Subject: Dresden Station Units 2 and 3  
Quad Cities Station Units 1 and 2  
Safety Parameter Display System  
Isolation Device Test Results  
NRC Docket Nos. 50-237/249 and 50-254/265

"ACROMAG" Testing Procedure  
 REVISION 1, DATED 1/17/86

SUBJECT: Isolation Device Test Results

5 Hot Voltage Injection: OBSERVE CAUTION WITH THIS SETUP!!!

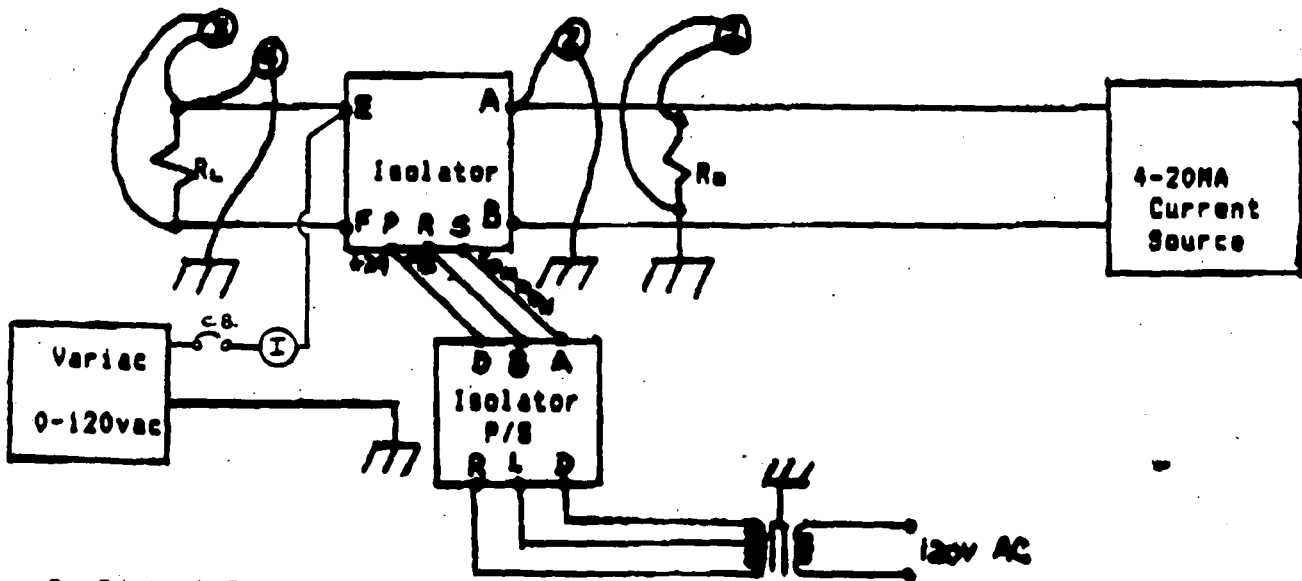
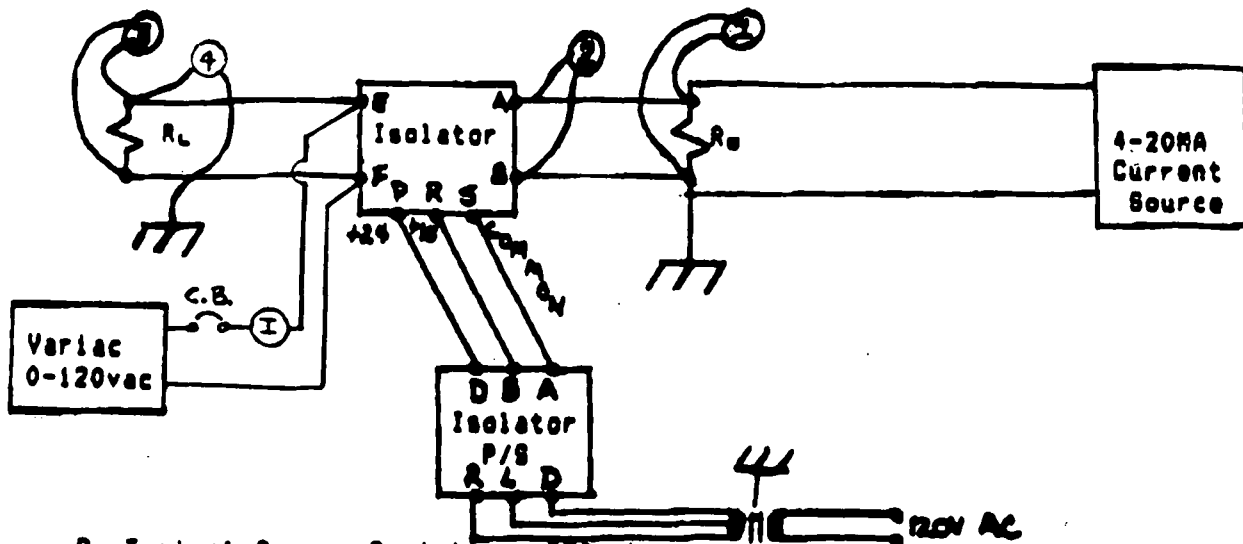
- 1) PROVIDE REVISION NUMBER AND DATE
- 2) INDICATE TYPE OF AMMETER TO BE USED
- 3) REVISE TEST #1 FOR VERIFICATION OF VARIAC OUTPUT RATHER THAN EQUIVALENT SOURCE IMPEDANCE
- 4) INCLUDE CIRCUIT BREAKER AND AMMETER IN TESTS #5 AND 6; ELIMINATE SOURCE RESISTOR
- 5) INCLUDE REFERENCE TO OAD CONSTRUCTION MANUAL

ALL REVISIONS INCORPORATED AS REVISION 1
